10/612,913

Office Action Summary

SUMINO ET AL.

DETAILED ACTION

Shimizu discloses in Figure 19A and respective portions of the specification a non-volatile semiconductor memory device as claimed.

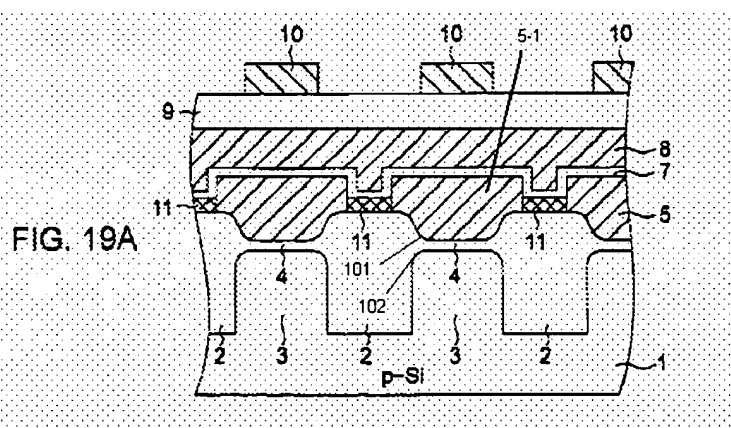
Referring to **claim 1**, Shimizu discloses a non-volatile semiconductor memory device comprising:

a semiconductor substrate (1) having a main surface provided with two spaced trenches (defined generally by isolation insulators 2);

an isolation insulator (2) filling said trench, said isolation insulator having an upper surface with an end having a curvature (101, as marked by the examiner) protruding toward said semiconductor substrate;

a floating electrode (5-1, as marked by the examiner) having a flat surface and extending from the main surface of said semiconductor substrate between said two trenches to said two isolation insulators;

an insulation film (7) extending from the upper surface of said floating electrode to a side surface of said floating electrode overlying said isolation insulator; and

a control gate (8) disposed on said insulation film to extend from the upper surface of said floating electrode to the side surface of said floating electrode.

Referring to **claim 2**, Shimizu further discloses that a sidewall surface of said trench and the main surface of said semiconductor substrate underling said floating electrode are connected together by a portion (102, as marked by the examiner) providing said semiconductor substrate with a curved surface.
